Model: LCIT 5020 / LCIT5010		Date: 23-May-11	No.: RB834002
Subject: New guide part for LCIT		Prepared by: H. Kawamura	
From: 1st PP Service Planning Sec., PP Service Planning			
Classification:	<input type="checkbox"/> Troubleshooting <input type="checkbox"/> Mechanical <input type="checkbox"/> Paper path <input type="checkbox"/> Product Safety	<input checked="" type="checkbox"/> Part information <input type="checkbox"/> Electrical <input type="checkbox"/> Transmit/receive <input type="checkbox"/> Other ()	<input type="checkbox"/> Action required <input type="checkbox"/> Service manual revision <input type="checkbox"/> Retrofit information <input type="checkbox"/> Tier 2

This RTB has been issued to announce that some parts for the LCIT have been changed

Model: Aries-C1.5 (D095)		Date: 28-Nov-11	No.: RD095010
Subject: Part Changes (Bearing & Plates)		Prepared by: A. Takada	
From: PP Tech Service Dept., 1st PP Tech Service Sect.			
Classification:	<input type="checkbox"/> Troubleshooting <input checked="" type="checkbox"/> Part information <input type="checkbox"/> Action required <input type="checkbox"/> Mechanical <input type="checkbox"/> Electrical <input type="checkbox"/> Servic

3.4TH/6TH PAPER TRAY 2 (B834)

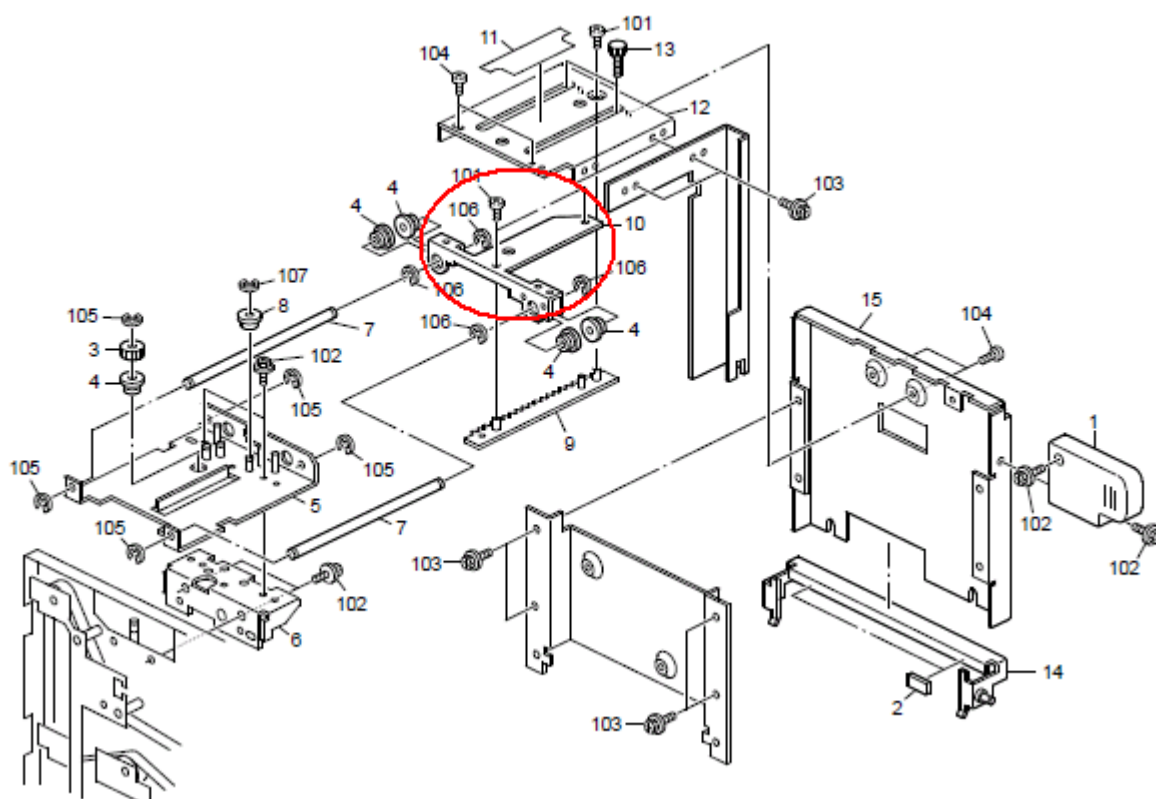
Old part number	New part number	Description	Q'ty	Int	Page	Index	Note
B8343332	B8343341	GUIDE:UPPER FRONT	1	x/x	7	10	B834
B8343334	B8343343	GUIDE:UPPER REAR	1	x/x	9	14	B834
B8343339	B8343345	RACK:UPPER	1	x/x	21	9	B834
B8343349	B8343345	RACK:UPPER	1	x/x	23	16	B834
D3553332	D3553334	GUIDE:LM-6:UPPER FRONT:PEEN	1	x/x	9	10	D355

B8343341

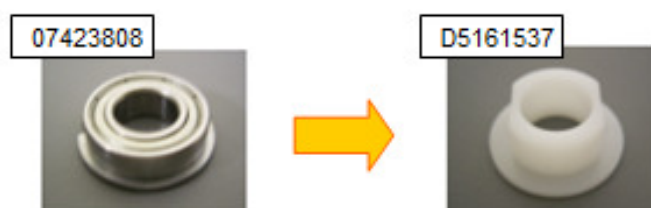
Change: Bearing and the shape of the accompanying plates

Reason: To share common parts with the LCIT RT5060 (D516)

1, The bearing was changed as shown in the photo below.

2, The size of the holes on the plates were reduced to correspond with the modified bearings.

121.Paper Tray 1 (D095)

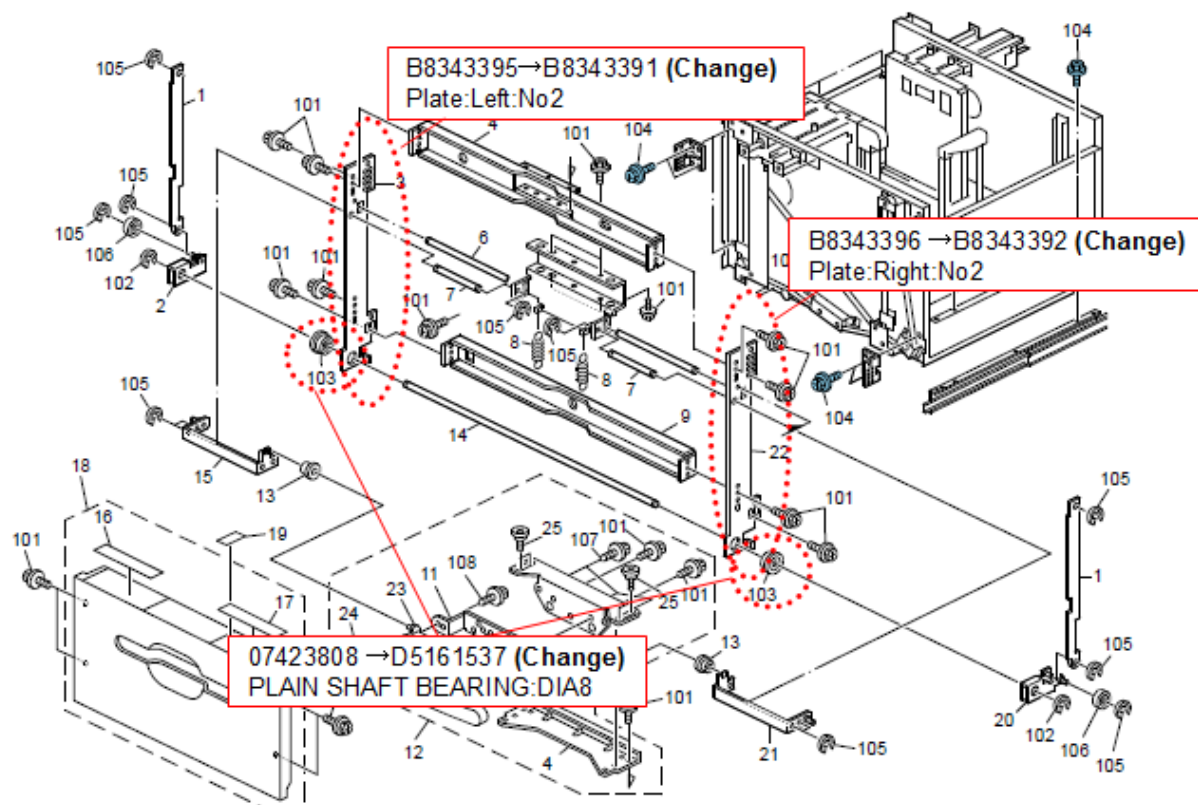
Old Part Number	New Part Number	Description	Q'ty	Int	Page	Index	Note
07423808	D5161537	Plain Shaft Bdaring:DIA8	2	X/O	266	103	
B8343395	B8343391	Plate:Left:No.2	1	X/O	266	3	
B8343396	B8343392	Plate:Right:No.2	1	X/O	266	22

- **Make sure all 3 parts shown in the above table are replaced as a set.**
- **The modification described in this bulletin also applies to Aegis-C1 (D016), Aries-C1 Lt (D097), LCT RT4000 (D350), LCT RT5020 (D355), and LCT RT5050 (D532).**

3.4TH/6TH PAPER TRAY 2 (B834)

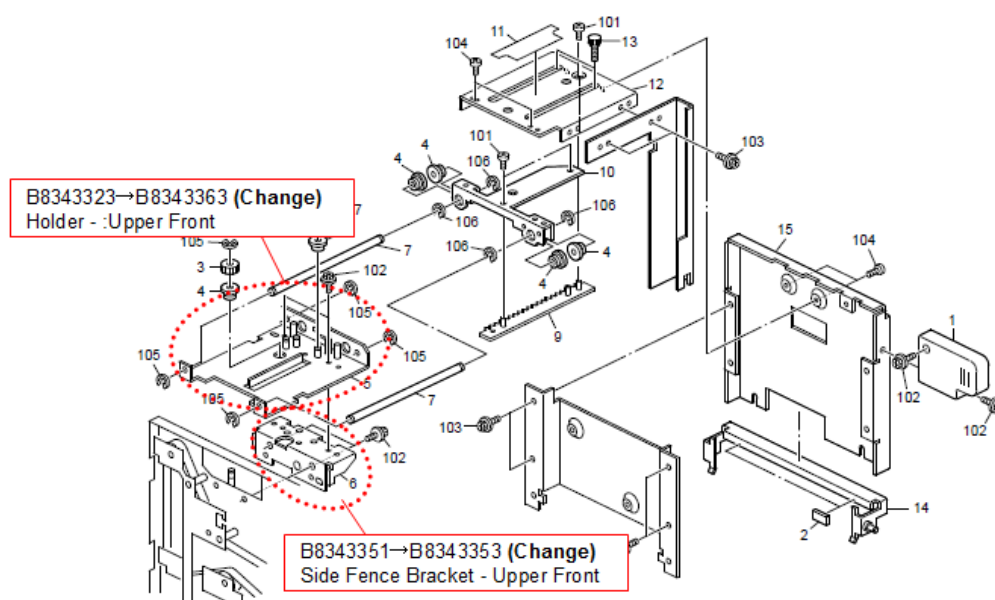
Change: Holder and Side fence bracket

Old Part Number	New Part Number	Description	Q'ty	Int	Page	Index	Note
B8343323	B8343363	Holder - :Upper Front	1	X/X	7	5	A
B8343329	B8343364	Holder - Upper Rear	1	X/X	9	21	A
B8343351	B8343353	Side Fence Bracket - Upper Front	1	X/O	7	6	A
B8343352	B8343354	Side Fence Bracket - Upper Rear	1	X/O	9	19	A

- **When replacing the above parts, replace all 4 parts as a set.**
- **The modification described in this bulletin also applies to Aegis-C1 (D016), LCIT RT4000 (D350), LCIT RT5020 (D355), LCIT RT5040 (D453).**

Changed parts

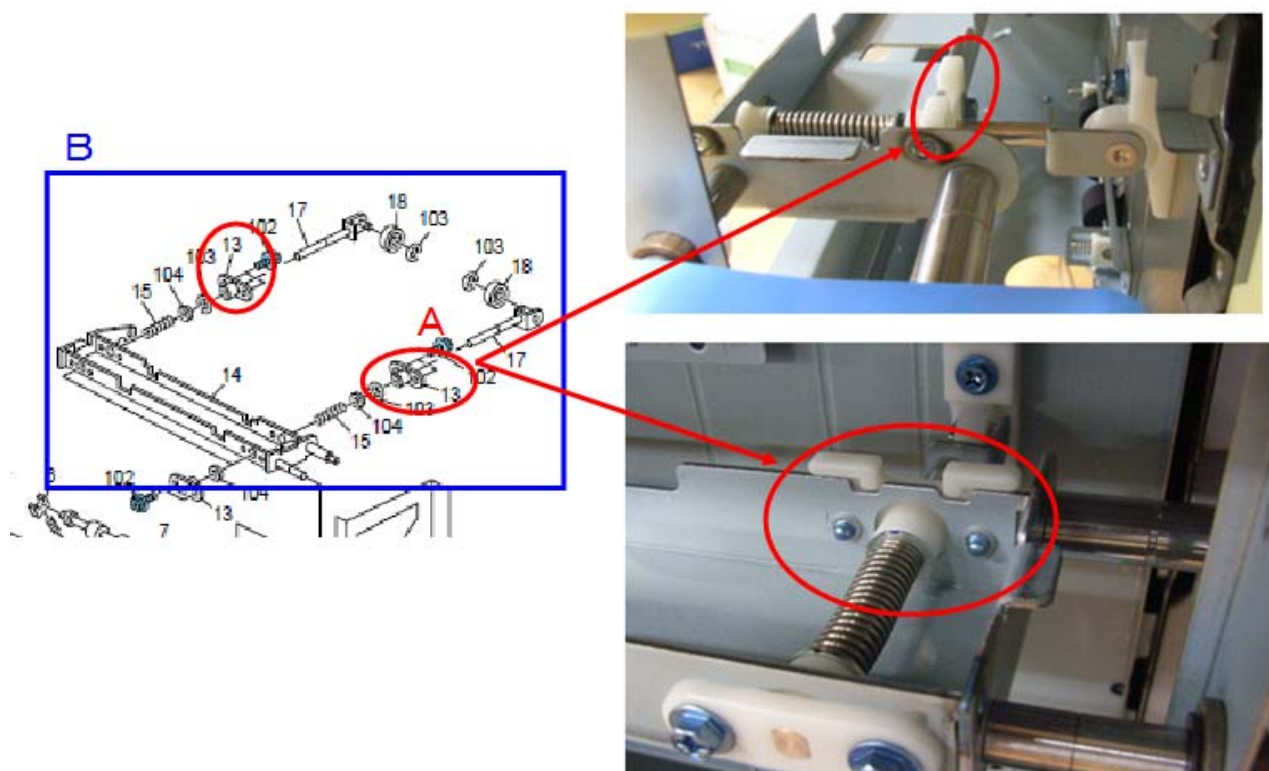
A : Shoe: Handle: Release

Shape of the Shoe was partially modified.

B : Handle: Ass'y

Handle was also modified in accordance with the shape change of the Shoe.
(Shape of the plate was also modified.)

- If the unit is now installed with D3553566, replace with D3553567. D5163847 is not needed.
- D5163847 can be attached ONLY to D3553567.
- The modification described in this bulletin also applies to Aries C-1.5 (D095), LCT RT5020 (D355), LCIT RT5050 (D532), and LCIT RT5060 (D516).

134.Transfer Section 1 (D016)

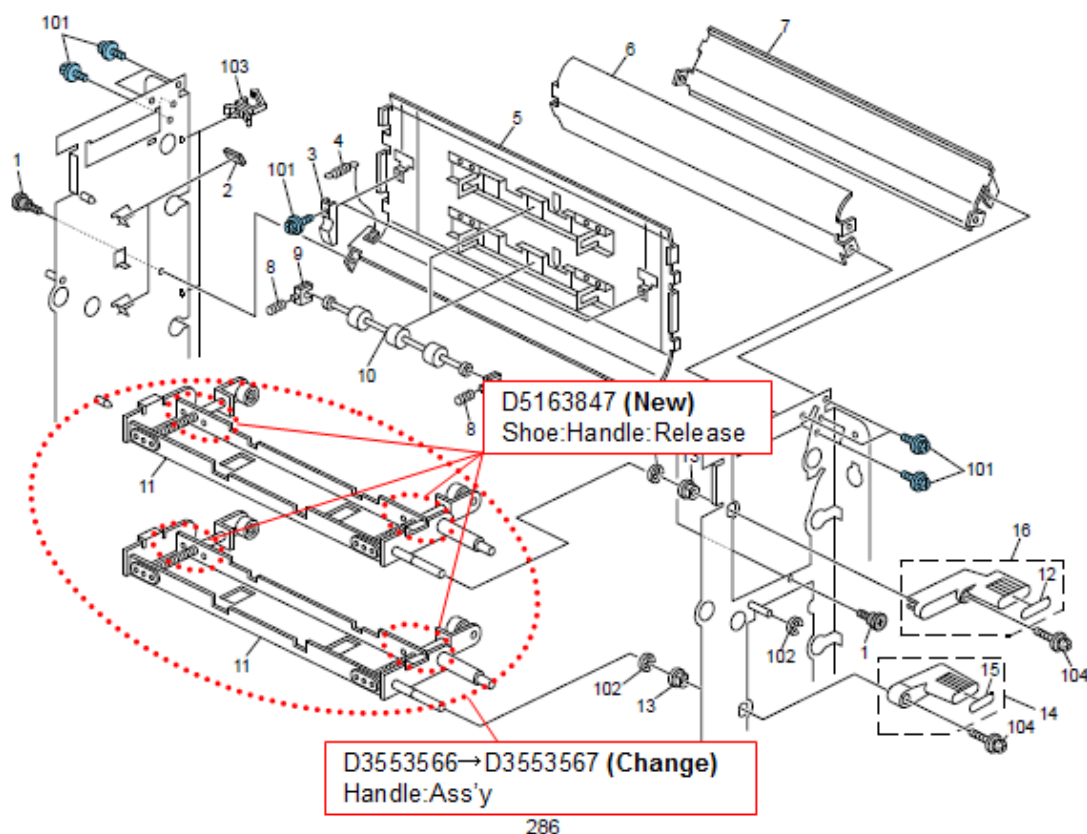
Old Part Number	New Part Number	Description	Q'ty	Int	Page	Index	Note
D3553566	D3553567	Handle:Ass'y	2	X/O	287	11	-
-	D5163847	Shoe:Handle:Release	4		287	17	-

106.Exterior 1 (D016)

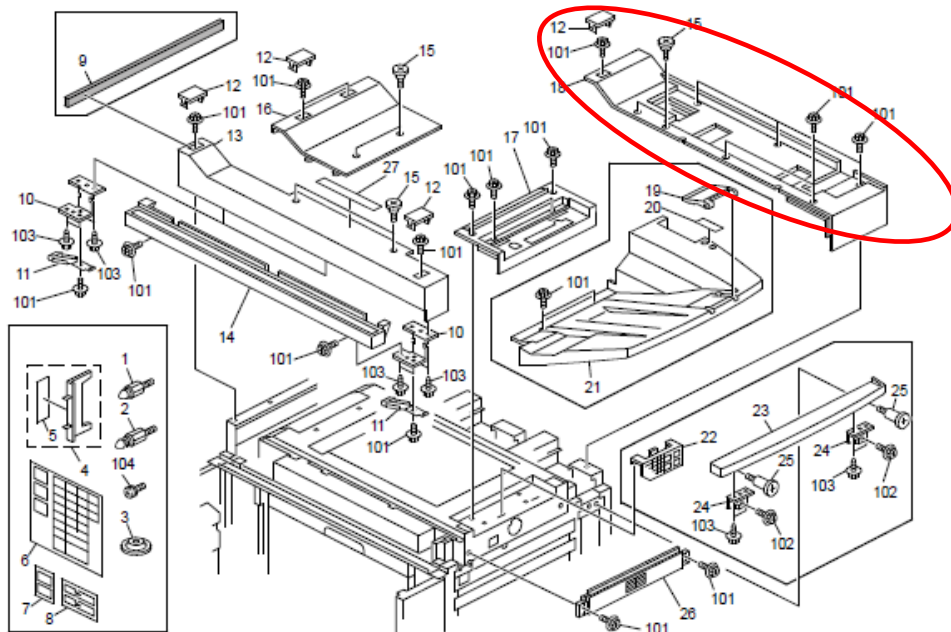
Change: Material of the scanner cover / addition of brackets

Reason: To improve the durability of the scanner cover

Old Part Number	New Part Number	Description	Q'ty	Int	Page	Index	Note
D0161980	D0161980	COVER:UPPER REAR:SCANNER	1	X/O as a set	231	18	*1
	D0161171	BRACKET:GROUND PLATE	5-6		257	5	*1
	D0161985	BRACKET:COVER:UPPER REAR:LEFT INNER REAR:SCANNER	1		257	13	*1

*NOTE 1: Interchangeability is X/O as a set.
